APPENDIX E.7.3

WSCC INSPECTION REPORTS AND BAFFINLAND RESPONSE

REPORT OF AN INSPECTOR OF MINES

Mine:	Milne Inlet
Operator:	BAFFINLAND IRON MINES CORPORATION
Mine Manager:	Michael Anderson
Date of Inspection:	January 20, 2015
Address:	300 - 2275 Upper Middle Road East Attn: Annu Sira Oakville, Ontario, L6H-0C3
Reference Number:	PR 2015-LL-00009

Photo 1: First 7.5m highwall exposed on top of mountain. Rock conditions are expected to improve once away from the surficial cap rock zone. It is understood that pre-shear holes were used on the left side of the photo but not on the right.

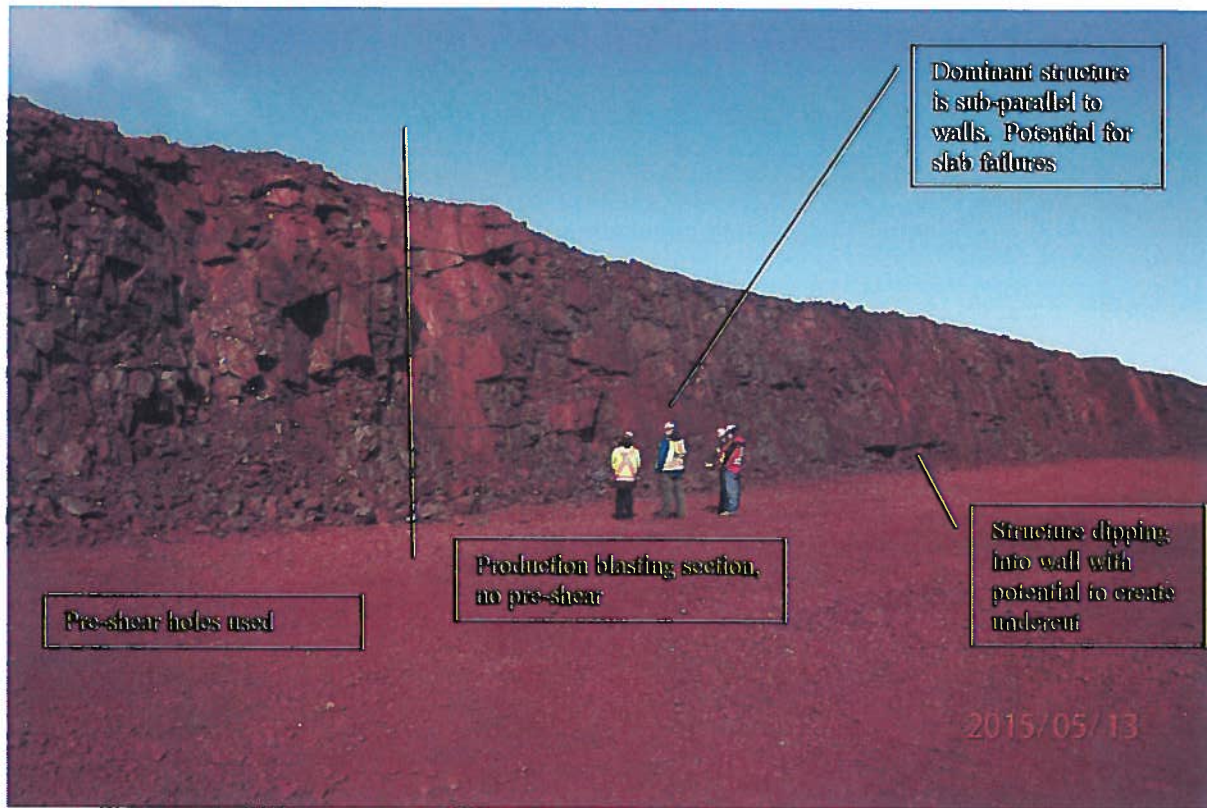
- Surface geomechanical mapping should be undertaken within the bulk-sample pit area to provide an enhanced understanding for the local variations in rock mass quality and for the bench-scale characteristics of the encountered discontinuities. This information will be especially relevant early in mine life. These initial pits will also provide some early feed-back on the impact of frost action and the influence of creating a seasonal active layer in the pit walls.*

- In order to provide comments on the Ultimate Pit, it was assumed that the same rock mass conditions encountered around the walls of the Payback Pit continued with depth. In order to upgrade the Ultimate Pit recommendations to a more detailed level of design, it will be necessary to validate these assumptions.*
